Product Change Notice (PCN)

PCN Number: **PCN-0456192R-01**

Product(s) Affected: **PJ-042**

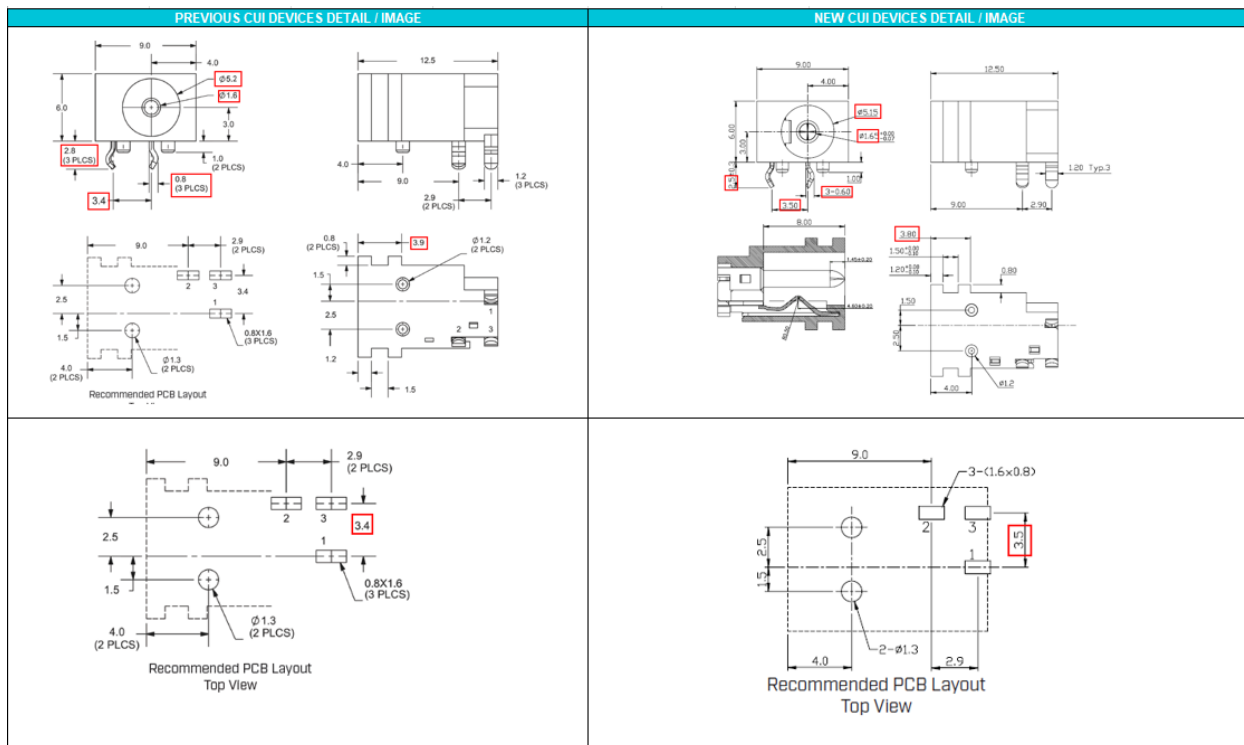
Description of Change: **New Factory Location. Product re-engineered for improved manufacturability and production yield. See image below for reference and check CUI Devices website for updated drawing. Cosmetic differences may be visible and not affect the form fit and function of the product.**

PREVIOUS CUI DEVICES DETAIL / IMAGE			NEW CUI DEVICES DETAIL / IMAGE		
DESCRIPTION	MATERIAL	PLATING/COLOR	DESCRIPTION	MATERIAL	PLATING/COLOR
center pin	brass	tin	center pin	bronze	tin
terminal 1	brass	tin	terminal 1	bronze t=0.35	tin
terminal 2	phosphor bronze t=0.3	tin	terminal 2	B2-Cu t=0.30	tin
terminal 3	brass t=0.3	tin	terminal 3	brass t=0.40	tin
housing	PAB6 (UL94V-0)	black	housing	PAB6-30%GF (UL94V-0)	black
MATING PLUG Jack Insertion Depth: 7.8 mm			MATING PLUG Jack Insertion Depth: 8.0 mm

Affected Date Code: All orders placed before **09/10/2024** will be pre-PCN parts. Orders placed after **09/10/2024** will be manufactured in accordance with the PCN. Please check updated 2D drawing on or after **09/10/2024**.
